GROUP CHA	MODEL 2015MY Sedona (YP)
	NUMBER 053	DATE March 2015
TECHNICAL SERVICE BULLETIN		
SUBJECT: SERVICE ACTION: SEDONA (YP) HYDRAULIC STEERING RACK INSPECTION AND/OR REPLACEMENT (SA182)

SUBJECT: SERVICE ACTION: SEDONA (YP) HYDRAULIC STEERING RACK INSPECTION AND/OR REPLACEMENT (SA182)

Reading the Date Code on the Steering Rack
4 J 1 7 (dots)

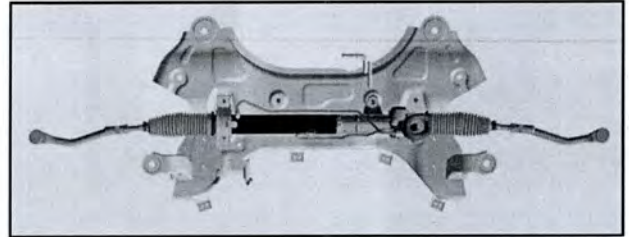
2. Locate the date code on the hydraulic steering rack. **NOTE: Refer to the table shown below to accurately read the date code information.**

3. If the rack date code matches 4 J 1 7 (dots), replace the rack with an improved part. Proceed to the Service Procedure on Page 3.
4. If the date code is different than 4 J 1 7 (dots), do NOT replace the rack. No further action is required.
